**ADVANCED ENERGY UNITED**  
**COMMENTS ON THE**  
**CENTERPOINT ENERGY’S 2025 INTEGRATED RESOURCE PLAN**

**Figure 3-4 – Alternate Scenario Forecasts**

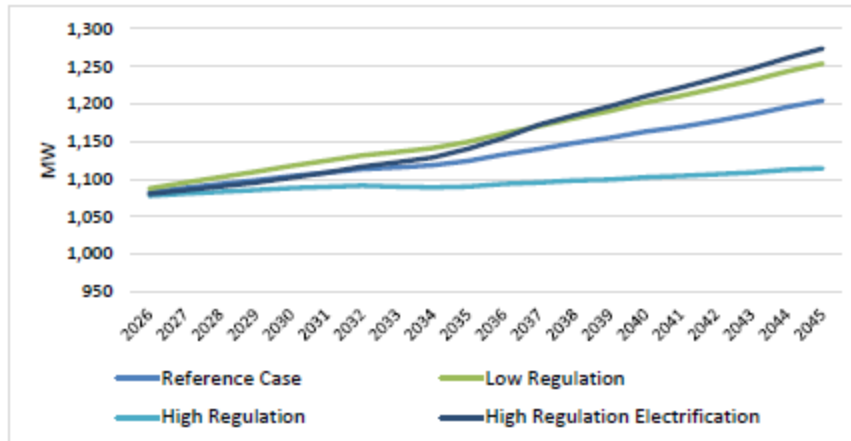
As discussed in the previous section, CenterPoint engaged in a robust process to craft its various modeling scenarios that are ultimately used to develop multiple different resource portfolios which are eventually evaluated using specific portfolio scoring measures to determine the “preferred resource portfolio”. One of the modeling scenarios that CenterPoint developed is the “Low Regulatory” scenario which represents a future where Clean Air Act (CAA) 111(b) and (d) are repealed, no new decarbonization mandates are introduced, Inflation Reduction Act (IRA) provisions are cancelled, and resource decisions are largely driven by market forces.<sup>30</sup> CenterPoint further states that “this scenario helps identify portfolios that remain viable in policy-light conditions with limited external drivers for transition”.<sup>31</sup> In other words, United understands this scenario to be indicative of a future with little to no regulatory and legislative oversight regarding resource decisions and greenhouse gas emission reductions. CenterPoint, when discussing Greenhouse Gase regulations, however, states that, “We believe it is unlikely that we will cease to have any regulatory requirements applicable to greenhouse gas emissions from fossil fuel-fired generating units”.<sup>32</sup> Ultimately, it appears that CenterPoint contradicts itself by stating that regulatory requirements applicable to greenhouse gas emissions from fossil fuel-fired generating units will likely exist in the future, while at the same time developing a modeling scenario that assumes the opposite. Overall, United questions why CenterPoint developed this aggressive “Low Regulatory” scenario given its statements on the future of greenhouse gas emission reductions, and ultimately recommends that CenterPoint discontinue the development of this modeling scenario in future IRPs.
